Agenda Report

July 10, 2017

TO: Honorable Mayor and City Council
FROM: Planning & Community Development Department
SUBJECT: PREDEVELOPMENT PLAN REVIEW OF A NEW MIXED-USE DEVELOPMENT AT 83 NORTH LAKE AVENUE

Proposed Site Plan

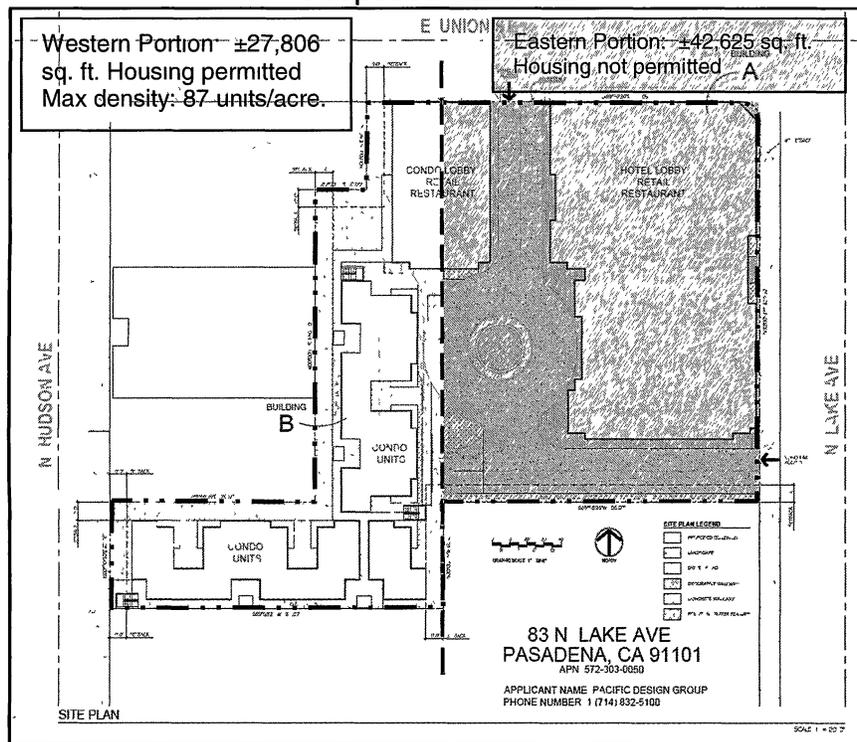
Within mixed-use buildings, commercial uses shall be located along street frontages and have a minimum depth of 50 feet. As proposed, no commercial uses are proposed along the Hudson Avenue frontage, and the proposal is not in compliance with the commercial frontage requirement for mixed-use buildings.

Density and Housing: Pursuant to Figure 3-4 of Section 17.30.030 of the Zoning Code, housing is permitted on the western portion of the site; however housing is not permitted within the eastern portion of the site. The maximum permitted residential density on the western portion of the site is 87 dwelling units per acre, and residential uses are not allowed on the eastern portion of the site.

The total lot size is 70,132 square feet, with the western portion measuring approximately 27,806 square feet, and the eastern portion measuring approximately 42,625 square feet. A maximum of 59 units are permitted within the western portion, and no units are permitted within the eastern portion.

The density bonus section of the Zoning Code (Section 17.43.040) permits a maximum of 35% increase in the number of units permitted on the site, without discretionary approval, provided a specified percentage are designated as affordable units. In this case, the maximum number of units permitted on the western portion of the property under the base zoning is 59 dwelling units, and a 35% increase would allow a maximum of 80. Based on the submitted application material, it does not appear that the project currently includes any such requests. As such, the project exceeds the maximum permitted density on the western portion, and contains residential units on the eastern portion. These elements do not comply with the zoning code.

Height: Pursuant to Figure 3-8 of Section 17.30.030 of the Zoning Code, the maximum building height limit is 75 feet (or 90 feet when the project utilizes height averaging). The submitted plans indicate that portions of the building would have a height of up to 88'-6". If the project pursues height averaging, it must comply with the following standards.

As currently designed, the proposed project would have a floor area of 216,084 square feet, or an FAR of 3.08, which exceeds this requirement.

The proposed building would consist of 7,055 square feet of retail area; 10,307 square feet of restaurant area; 139 hotel rooms; and 97 residential units. The maximum required parking is 440 spaces and the minimum required parking is 362 spaces. The proposed plans indicate that 492 parking spaces would be provided in a three level subterranean garage. The number of parking spaces provided would have to be reduced by 76 spaces to comply with the maximum permitted.

1. In general, the logic of the massing and articulation of the building is unclear and appears to be inconsistent with design guidelines. Based on the site and floor plans, the building appears to be a vertically extruded building footprint with little relief in the building walls. Explore ways to provide greater articulation of the building massing and create more significant separations between portions of the building that differ in character, such as the rounded, curving components and the framed components along Union Street. Consider step-backs or other treatment at the corner of Lake Avenue and Union Street to avoid overpowering the corner with extruded building massing.

5. A large portion of the ground floor of the site is devoted to a vehicular circulation and should be further studied to identify ways to lessen the vehicular focus of the project and possibly provide an opportunity for grade-level open space, which is lacking in the project design. Explore ways to make this area more pedestrian-focused and inviting while allowing the necessary vehicular functionality. Consider an open-air lobby entry to encourage pedestrian movement.

6. Along Hudson Avenue, an articulated entrance to the condominiums (either a secondary lobby or direct entry to the street-facing ground-level unit) at that location should be provided, closer to the street.

7. The southerly driveway is proposed adjacent to a large expanse of driveway on the adjacent site to the south, creating a large vehicular access interruption in the pedestrian environment along Lake Avenue. Explore options to either relocate this driveway or to share access with the adjacent site to the south.

12. There should be a greater level of pedestrian permeability through the site, responding to the City's tradition of alley walkways and passages as well as the project's proximity to the Playhouse District. Consider including a pedestrian pathway through the site from Lake Avenue to Mentor Avenue. Look to the site design of the Plaza las Fuentes project, which includes features of the exterior open spaces continuing into the interior lobby as well as a smaller, more urban drop-off zone.
